UNITED STATES PATENT AND TRADEMARK OFFICE

APPLICATION NO.	FILING DATE	FIRST NAMED INVENTOR	ATTORNEY DOCKET NO.	CONFIRMATION NO.
10/817,620	04/01/2004	Carl Woods	LAM2P474	2464
25920 7590 08/31/2007 MARTINE PENILLA & GENCARELLA, LLP 710 LAKEWAY DRIVE SUITE 200 SUNNYVALE, CA 94085			EXAMINER WATSON, JOY L	
			ART UNIT 1762	PAPER NUMBER
			MAIL DATE 08/31/2007	DELIVERY MODE PAPER

Office Action Summary	Application No. 10/817,620	Applicant(s) WOODS, CARL	
	Examiner Joy Watson	Art Unit 1709

DETAILED ACTION

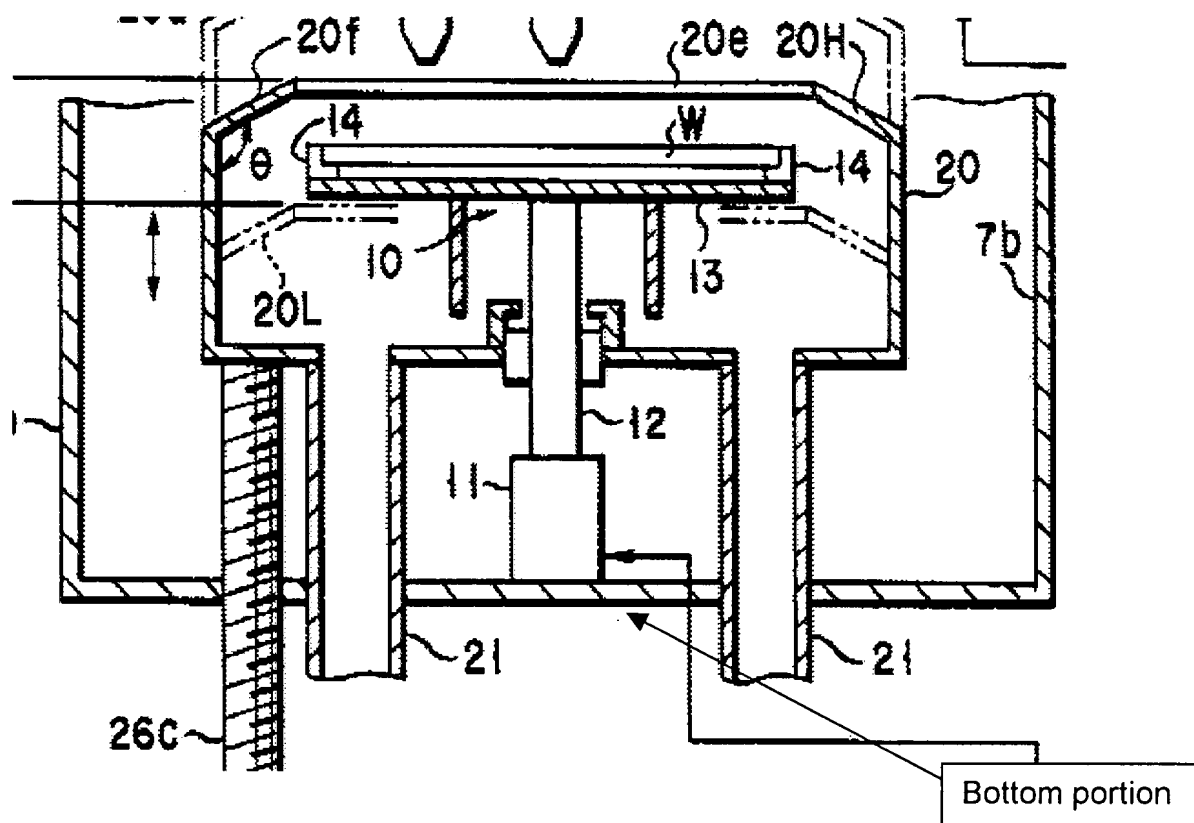
'479 teaches the apparatus according to Claim 6 and additionally teaches the coupon magazine (20) including a top portion and a bottom portion. (See Figure below).

'479 teaches the apparatus according to Claim 7 wherein the docking station (20) includes a top (20f and 20h) and bottom portion (See Figure below taken from Fig. 13 of Prior Art).
